Re: Dunwoody Cultural Arts Center HVAC Roof Top Unit System Replacement

Cultural Arts Center – RTU Assessment

City of Dunwoody

Date: 4/18/2025

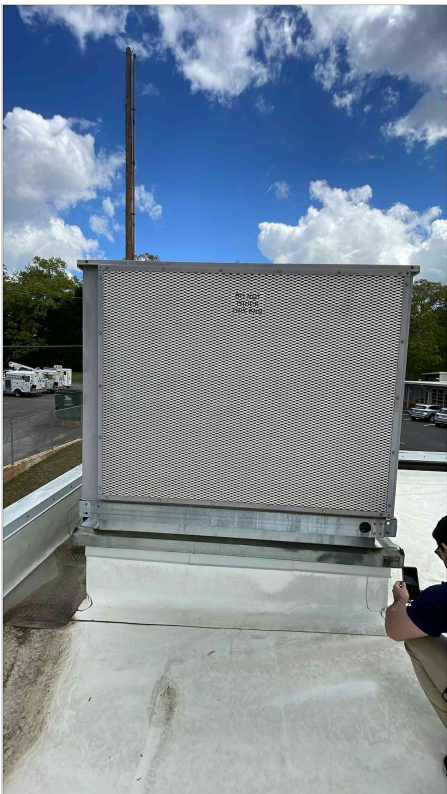
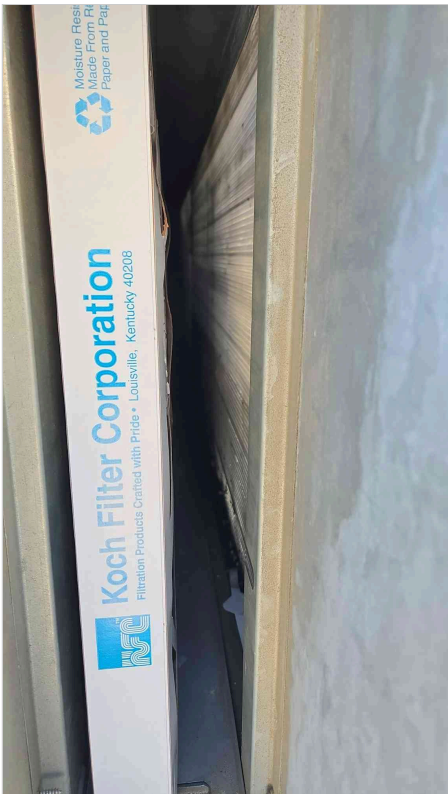
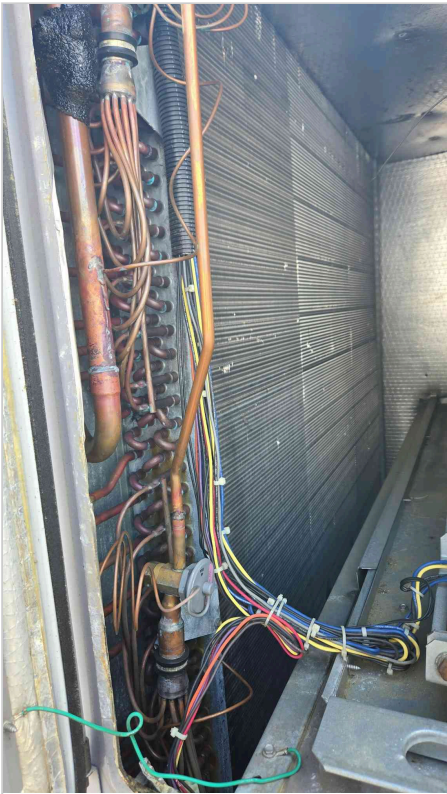
Number	Description	Status	Priority	Asset	Assigned	Due Date
FO-1-12	Controls Overview: - Space temperature is not shown on graphics. Is space temperature integrated? - RA temperature sensor shown as 0.0F on graphic. Is it installed and integrated?	OPEN		RTU-1		4/14/2025

From preliminary testing, RTU-1 is able to move into heating and cooling modes and leaving air temperature changes to accommodate the various modes.

Based on visual observation, the drive assembly for the fan is in good condition and the belt is not slipping substantially or noisy.

The natural gas furnace for reheat appears to be operable. 44 kW.

The unit was manufactured, and likely installed, in 2011. A typical lifecycle for well-maintained packaged RTU equipment is 15-20 years. Although the unit is approaching 15 years old, it is in good mechanical condition for its age.

The unit appears to be regularly serviced and well-maintained.

The coils are in a good condition. The unit is generally clean.

The filters are clean.

The condenser section is in a good condition.

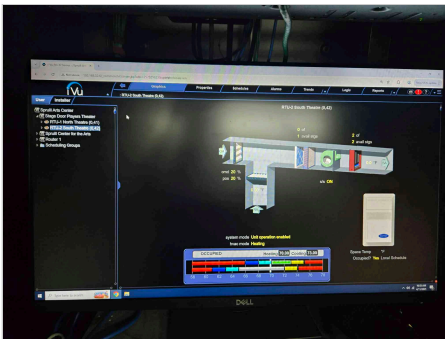
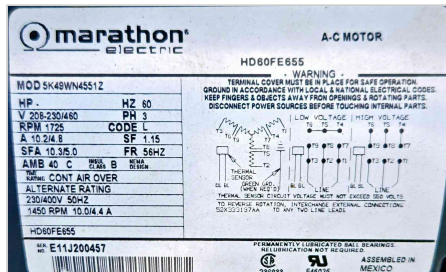
Number	Description	Status	Priority	Asset	Assigned	Due Date
FO-1-21	Consider piping condensate to a sloped portion of the roof to eliminate pooling of water.	OPEN		RTU-2		4/15/2025
FO-1-13	Controls Overview: - Space temperature is not shown on graphics. - RA temperature displayed as 0.0F on graphics. Is this point integrated and installed? - Supply Air Temperature sensor cycles its reporting and operation. Unreliable.	OPEN		RTU-2		4/14/2025
FO-1-2	The insulation on the interior of the unit needs to be replaced. This is common for units of this age.	OPEN		RTU-2		4/14/2025
FO-1-1	OA in take bird screen is broken.	OPEN		RTU-2		4/14/2025

Equipped with natural gas furnace reheat, 44 kW.

The condenser section is in a good condition.

The coils are in a good condition. The unit is generally clean.

The unit appears to be regularly serviced and well-maintained.

The unit was manufactured, and likely installed, in 2011. A typical lifecycle for well-maintained packaged RTU equipment is 15-20 years. Although the unit is approaching 15 years old, it is in good mechanical condition for its age.

Filters were clean.

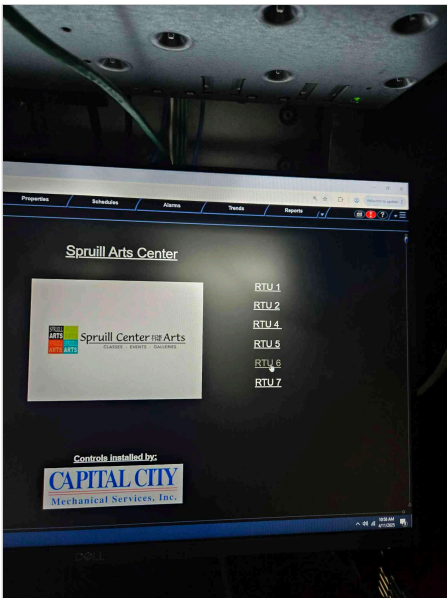
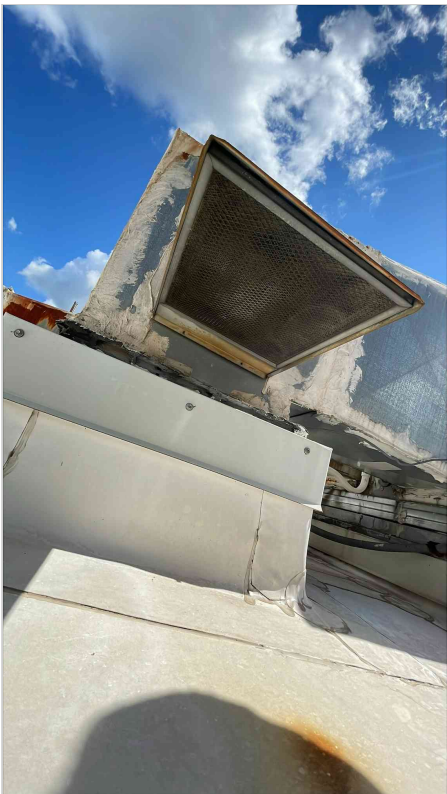
Number	Description	Status	Priority	Asset	Assigned	Due Date
FO-1-22	Design external static pressure is 1"w.c. Measured at 0.8"w.c. This indicates the unit is likely not meeting original design airflow. This is expected for a unit of this age.	OPEN		RTU-3		4/15/2025
FO-1-17	It seems that RTU-3 is not connected with the BAS system. Unable to determine if unit is able to enter into heating and cooling. At the time of testing, the unit was running and recirculating air (not heating or cooling).	OPEN		RTU-3		4/14/2025
FO-1-3	OA intake is clogged. There is no way to set OA flow.	OPEN		RTU-3		4/14/2025

Equipped with natural gas furnace reheat.

The unit was manufactured, and likely installed, in the late 90's or early 00's. A typical lifecycle for well-maintained packaged RTU equipment is 15-20 years. The unit is likely over 25 years old and is at the end of its useful life.

Filters are clean.

Condenser is in a good condition.

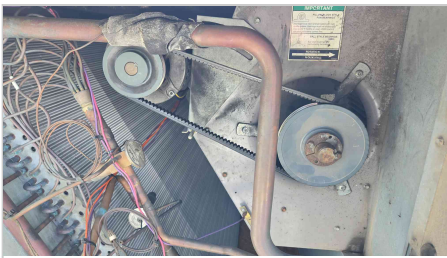
Number	Description	Status	Priority	Asset	Assigned	Due Date
FO-1-16	Some sensor values for the rooms associated with RTU-4 are not shown on graphics.	OPEN		RTU-4		
FO-1-15	The system is not cooling even when the thermostat cooling setpoint is changed to cooler values. A number of RTU-4 associated terminal devices appear to be inoperable based on the BAS.	OPEN		RTU-4		4/14/2025
FO-1-14	The unit cannot keep the space temperature within the range defined by thermostat. The current space temperature is 77.2 while the cooling setpoint is 70 (for an associated box). RTU-4 graphic is unclear.	OPEN		RTU-4		4/14/2025
FO-1-6	The condenser coil is damaged and much of the exterior of the unit is rusted.	OPEN		RTU-4		4/14/2025
FO-1-5	The drain pipe from the cooling coil is broken.	OPEN		RTU-4		4/14/2025
FO-1-4	Drain pan is rusted.	OPEN		RTU-4		4/14/2025

Based on visual observation, the drive assembly for the fan is in good condition and the belt is well tensioned however the unit is off.

Filters are partially loaded. Cooling coil in clean condition.

Equipped with natural gas furnace reheat, 54.5 kW.

The unit was likely manufactured and installed in the early 00's. A typical lifecycle for well-maintained packaged RTU equipment is 15-20 years. The unit is likely almost/over 25 years old and is at the end of its useful life.

The unit was off when assessment was conducted. Unable to confirm if unit can properly heat and cool.

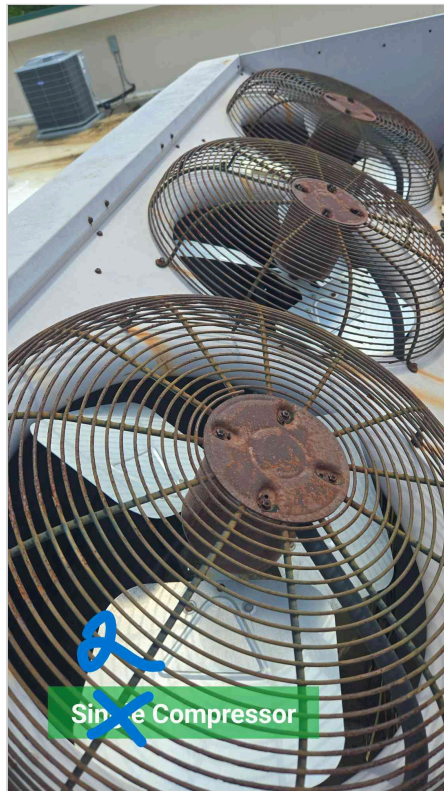
Number	Description	Status	Priority	Asset	Assigned	Due Date
FO-1-19	The BAS system does not show a lot of values such as system air temp and pressure.	OPEN		RTU-6		4/14/2025
FO-1-10	Condensing coil is damaged.	OPEN		RTU-6		4/14/2025

The unit was likely manufactured and installed in the early 00's. A typical lifecycle for well-maintained packaged RTU equipment is 15-20 years. The unit is likely almost/over 25 years old and is at the end of its useful life.

The ductwork interior is not damaged but needs to be cleaned.

Unit was not running at time of assessment and operator indicated the unit was off due to a needed controls repair. Unable to confirm if unit can properly heat and cool.
